Rudd Avenue to Serpentine Lane Path Improvements

November 24, 2020

Current Pathway Design - Changes

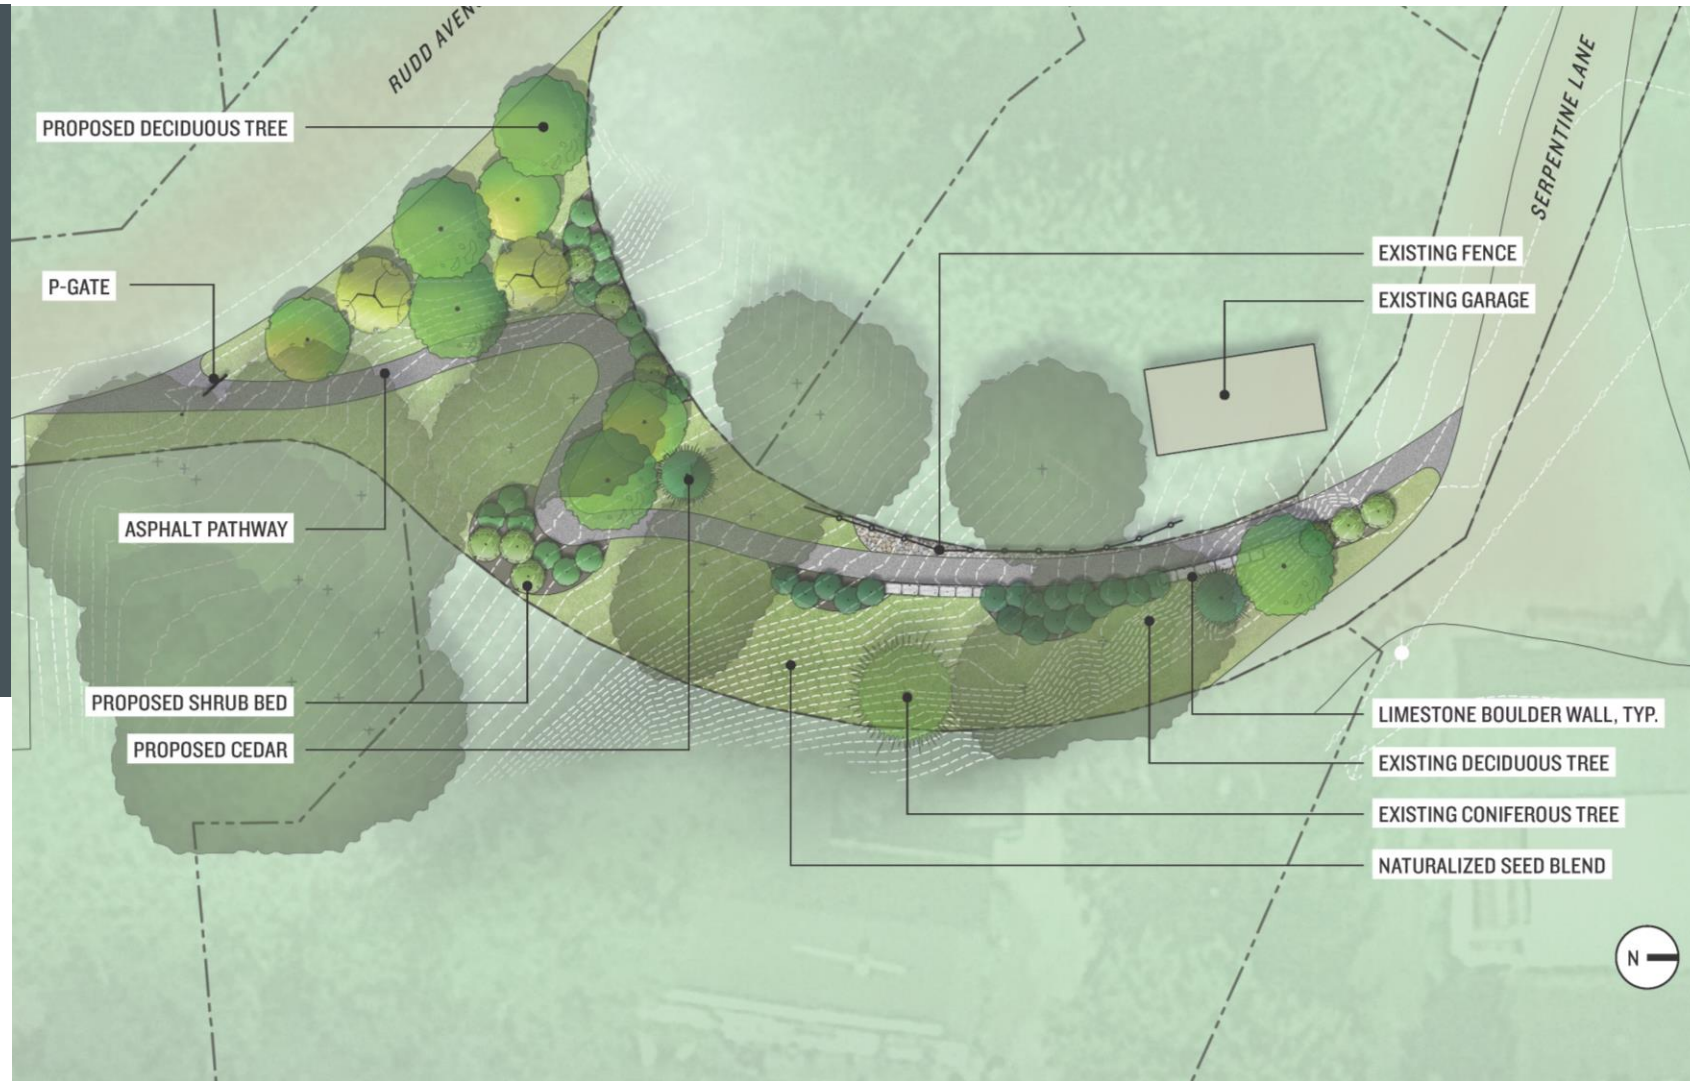
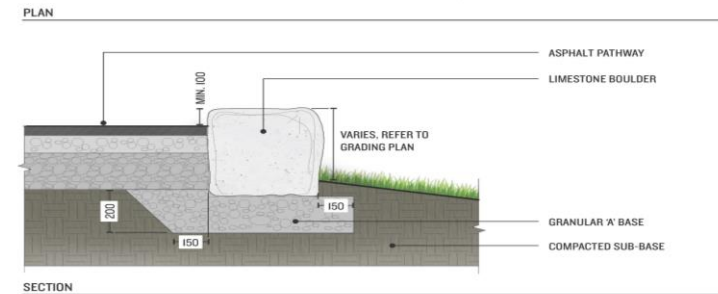
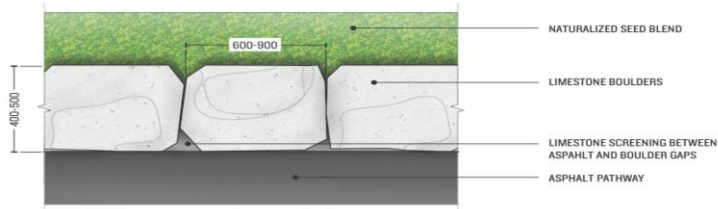
Feedback/questions received on project and original concept plan:

- The footpath has been regularly used by residents to go to the school bus, mailboxes, to visit friends and for walks out on to Abbey Dawn Rd. and Highway #2.
- The pathway improvement is much needed and important.
- Kids ride their bicycles on the existing foot path.
- The path connection at the top on the Rudd Avenue corner has limited visibility.
- Steep slope at the bottom of hill currently a challenge to users
- The aesthetic of the space is important (currently natural)
- A better integration of the pathway into the natural space is preferred.
- Less change and disruption to the site is preferred
- Naturalization and habitat for wildlife is important
- Some felt bench was unnecessary
- Concerns over privacy and increased usage by people from outside the neighbourhood
- Pathway is a little close to neighbouring residents.

Less change of grades and more mature trees to be retained

Narrower path surface

Smaller retaining walls

No stairs or bench

More new trees & woody shrubs added for diversity, habitat and aesthetics

Pedestrian gate added at Rudd Avenue
